Design Review Report – Item 1

Local government:	City of Stirling	
Item no.:	Item 1 – DA25/0012 – 435 Scarborough Beach Road, Osborne Park – Development Application – Showrooms with associated car parking and landscaping	
Chairperson:	Philip Gresley	
Panel members:	Tony Blackwell Peter Ciemitis Jackson Liew	
Local government officers:	Karina Bowater Shaun Wheatland Sam Michie Simone Palmer	Acting Coordinator Planning Acting Coordinator Planning Acting Senior Planning Officer DRP Support Officer
Observers	Zeinab Kashmar Nayan Khairnar Adam Stillitano	Planning Officer Planning Officer Senior Planning Officer
Date:	27 February 2025	Time: 2pm
Venue:	City of Stirling – Challenger Room

Design quality evaluation Item 1 – DA25/0012 – 435 Scarborough Beach Road, Osborne Park – Development Application – Showrooms with associated car parking and landscaping DRP Meeting – Thursday 27 February 2025		
	S	<i>Design Principle satisfied</i>
	P	<i>Design Principle pending further attention</i>
	N	<i>Design Principle not satisfied</i>
Principle 1 Context and character		<i>Good design responds to and enhances the distinctive characteristics of a local area, contributing to a sense of place.</i>
	P	1a

BUILDING 2 WEST ELEVATION

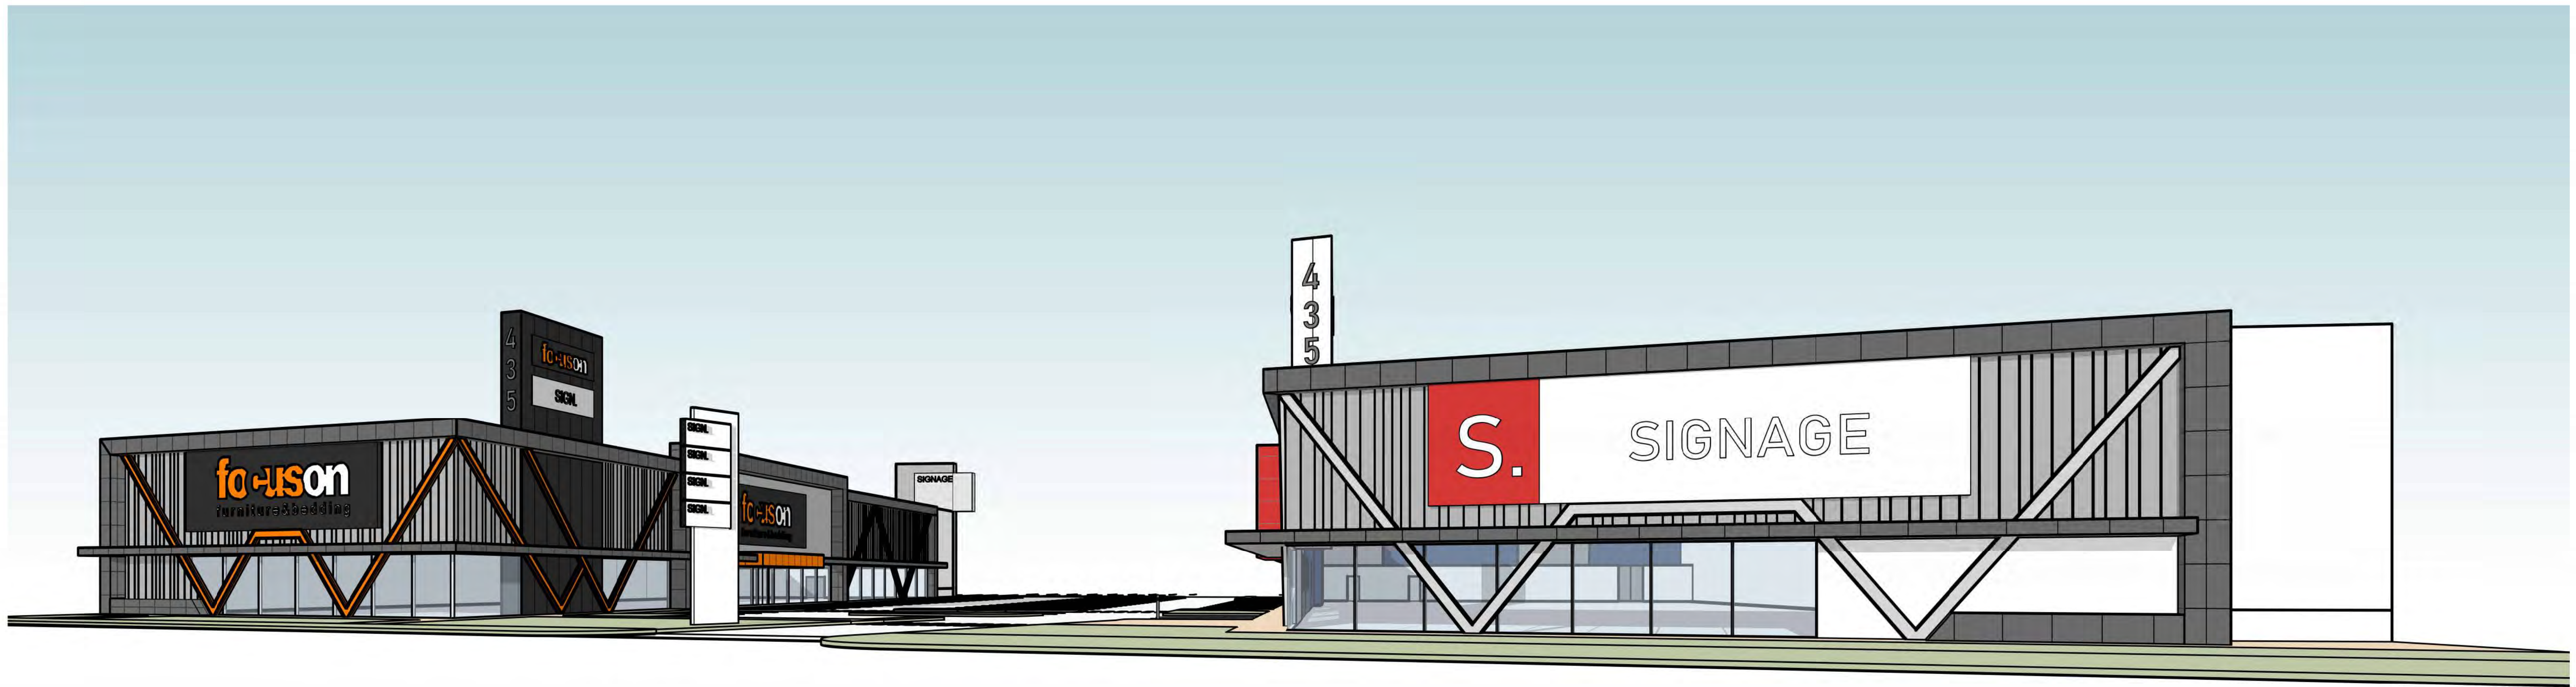
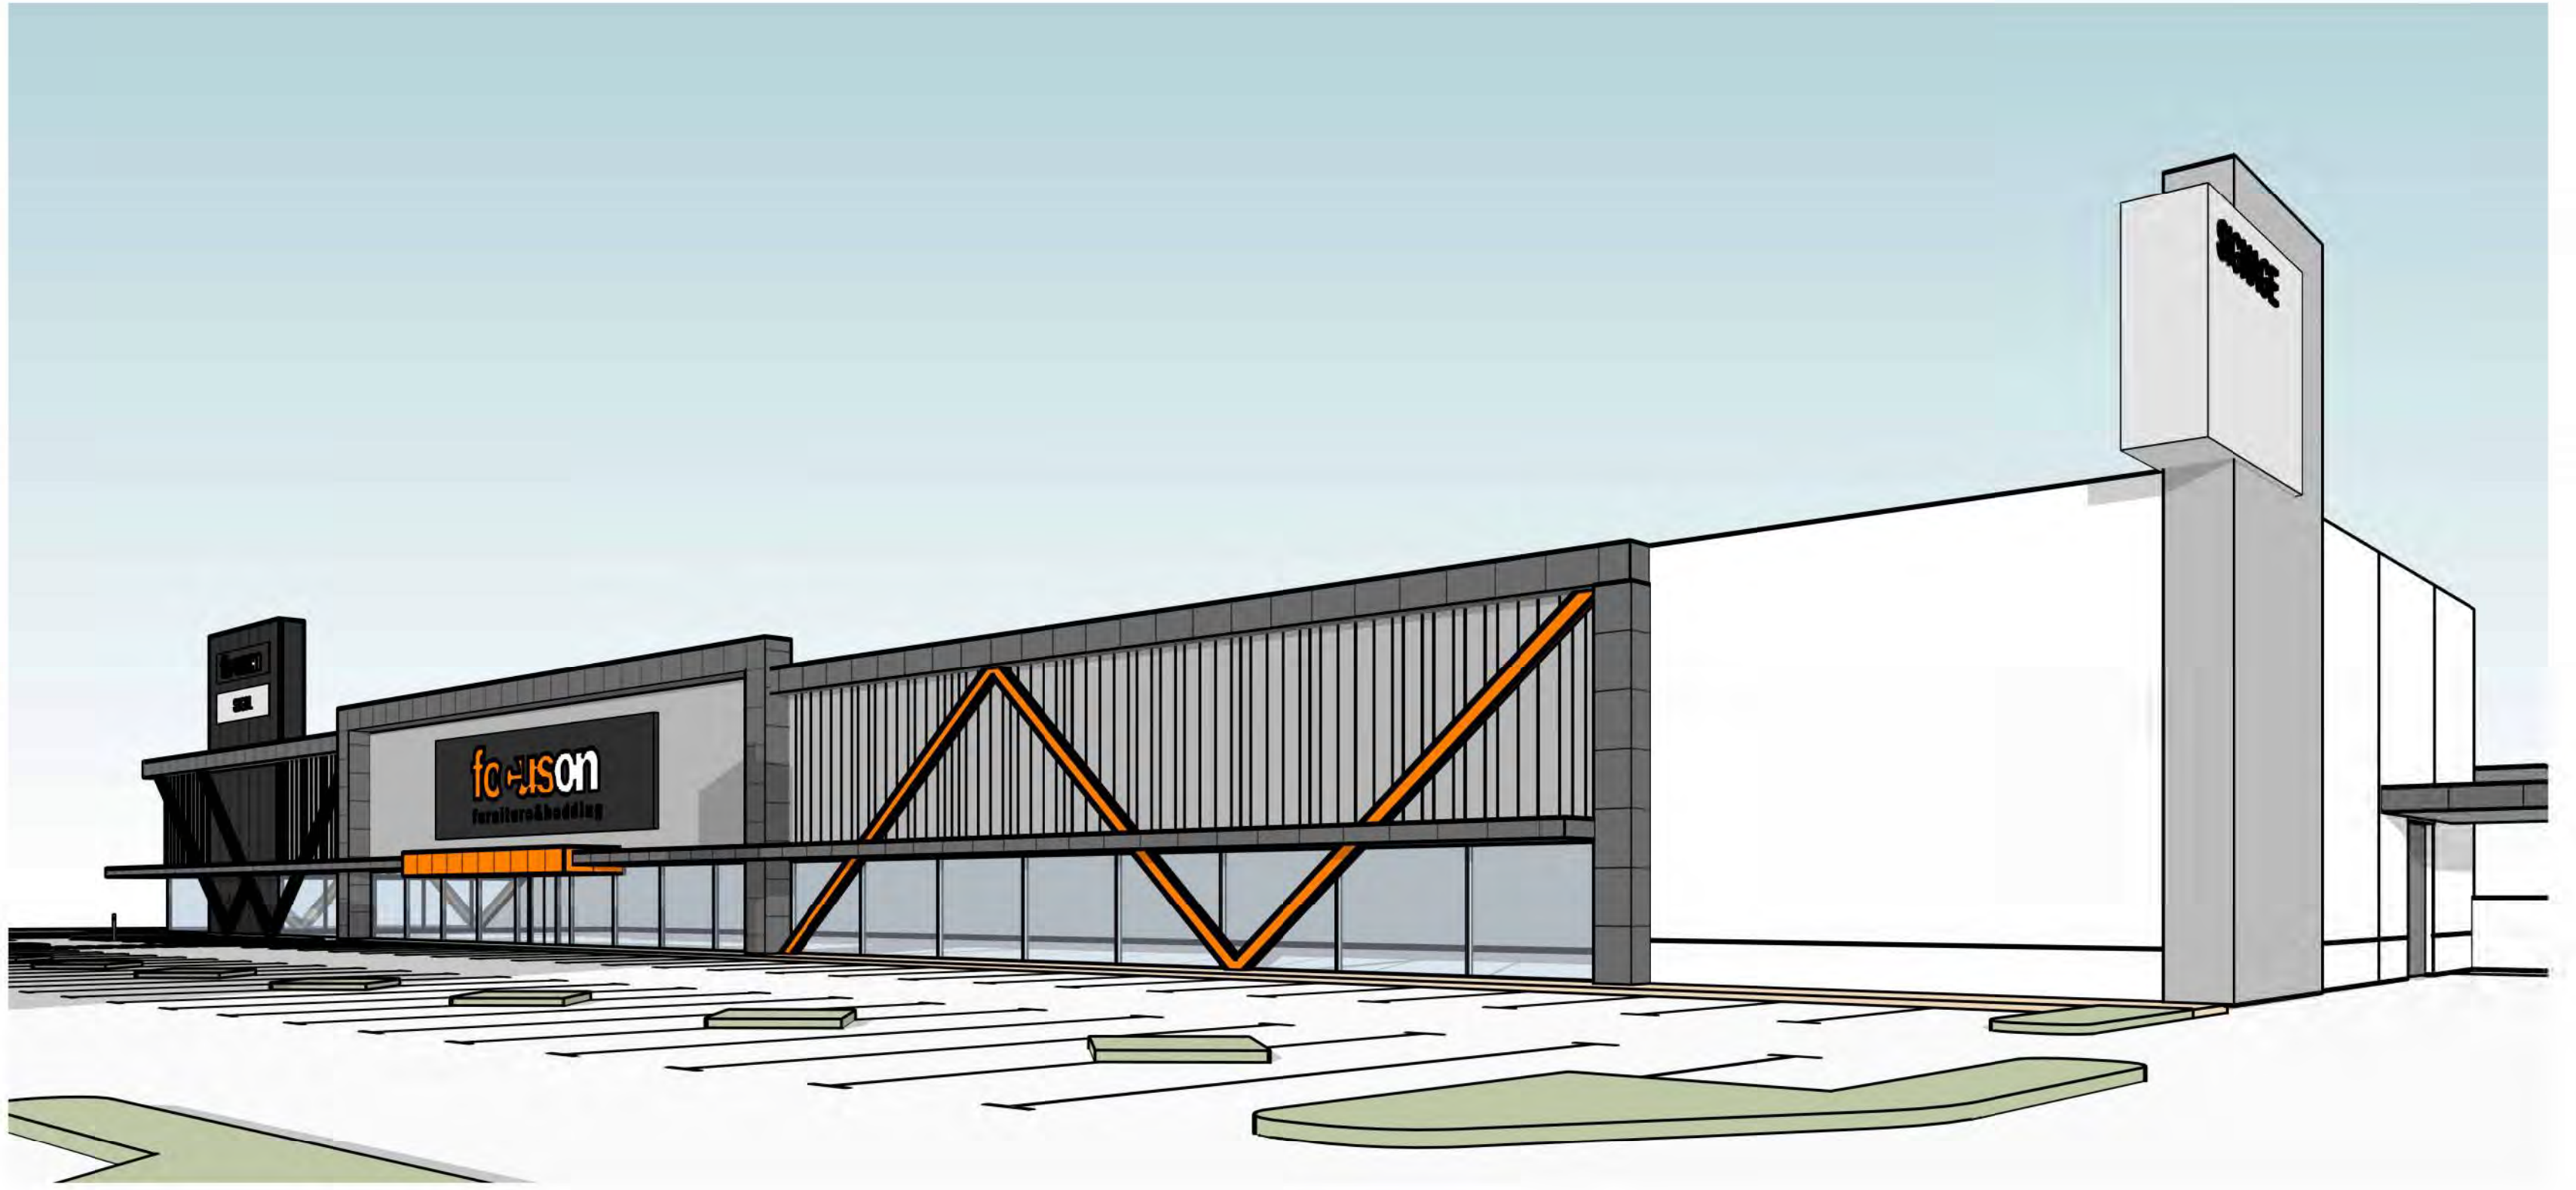
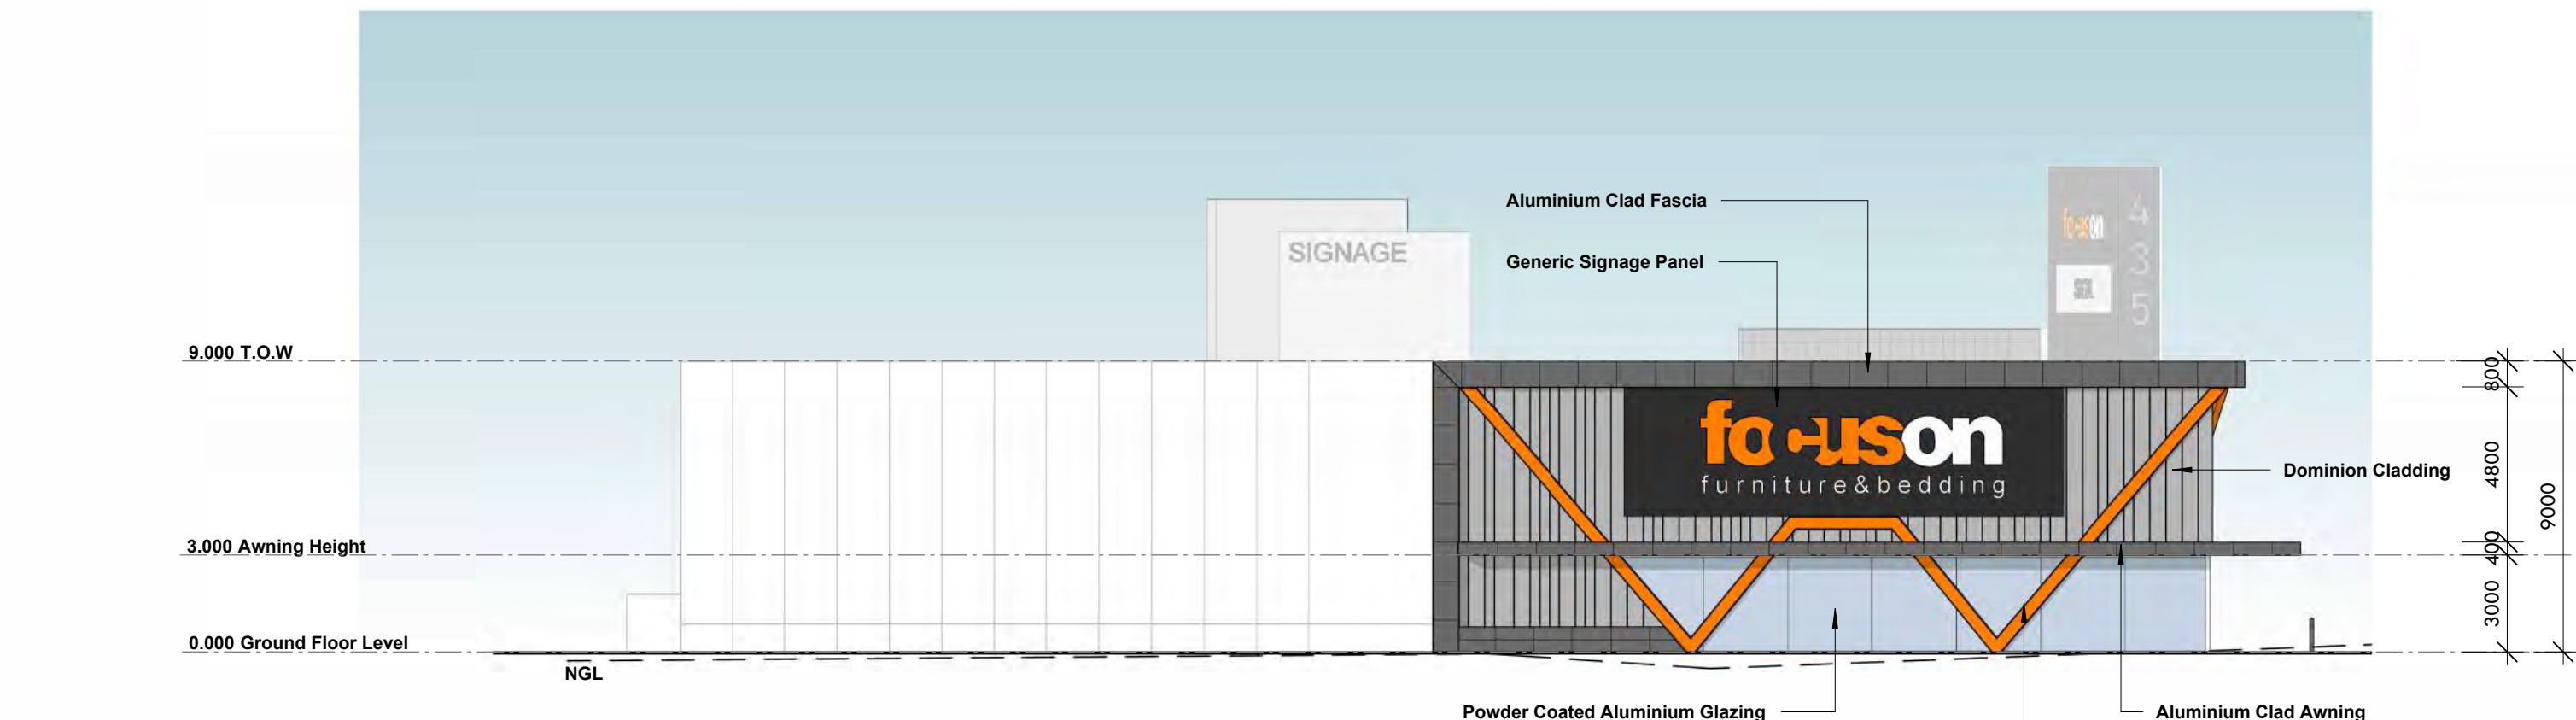
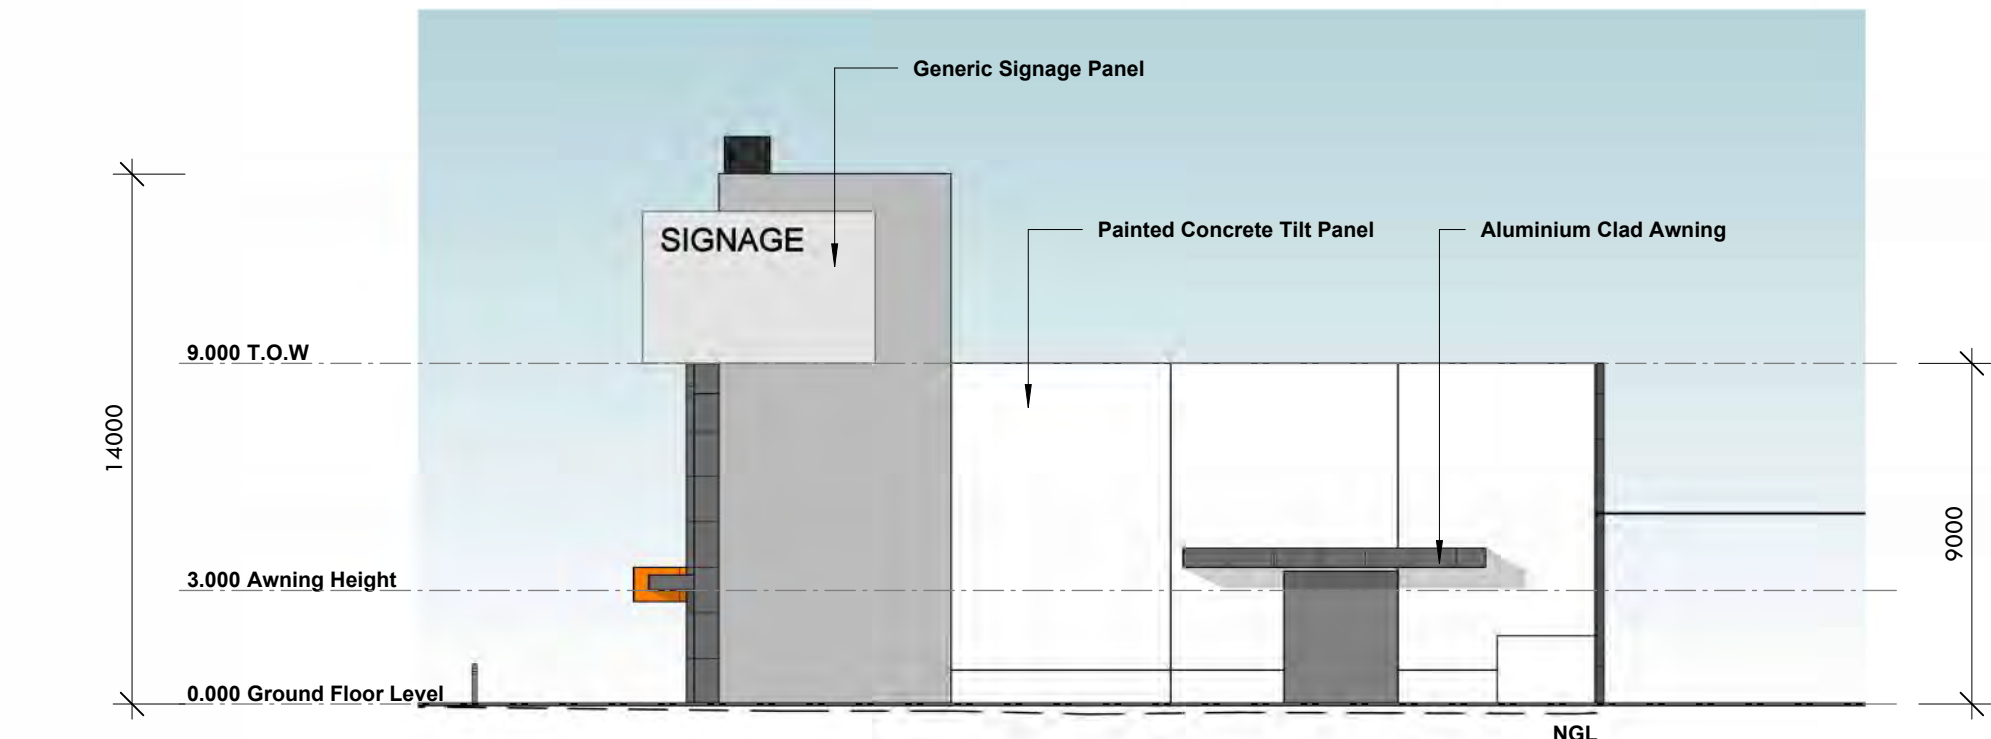
Principle 10 Aesthetics		<i>Good design is the product of a skilled, judicious design process that results in attractive and inviting buildings and places that engage the senses.</i>
	P	10a. The southwest corner of Building 2, which has a strong presence within the car park, should be further refined to enhance its architectural articulation and visual impact. Given its prominence, this corner presents an opportunity to better engage with the public realm and reinforce the overall design language of the development. 10b. The building signage strategy is overly cluttered, detracting from the overall aesthetic quality of the development. The excessive number of signs diminishes their effectiveness and creates visual noise. A more restrained and cohesive approach to signage would improve both tenant visibility and the overall architectural expression of the building. 10c. The Panel encourages the use of pedestrian awnings. Additionally, the retail entry points should be more clearly defined in the architecture, both for legibility and as an opportunity to enhance the overall aesthetics of the development. 10d. The large angled structural gestures are inconsistent with the intended future character outlined in the Local Development Plan (LDP). While the current "big box" format suits the existing context, the Panel recommends refining the architectural composition to ensure the built form is more articulated and responsive to the area's evolving character.

10a. The southwest corner of Building 2, which has a strong presence within the car park, should be further refined to enhance its architectural articulation and visual impact. Given its prominence, this corner presents an opportunity to better engage with the public realm and reinforce the overall design language of the development. 10b. The building signage strategy is overly cluttered, detracting from the overall aesthetic quality of the development. The excessive number of signs diminishes their effectiveness and creates visual noise. A more restrained and cohesive approach to signage would improve both tenant visibility and the overall architectural expression of the building. 10c. The Panel encourages the use of pedestrian awnings. Additionally, the retail entry points should be more clearly defined in the architecture, both for legibility and as an opportunity to enhance the overall aesthetics of the development. 10d. The large angled structural gestures are inconsistent with the intended future character outlined in the Local Development Plan (LDP). While the current "big box" format suits the existing context, the Panel recommends refining the architectural composition to ensure the built form is more articulated and responsive to the area's evolving character.
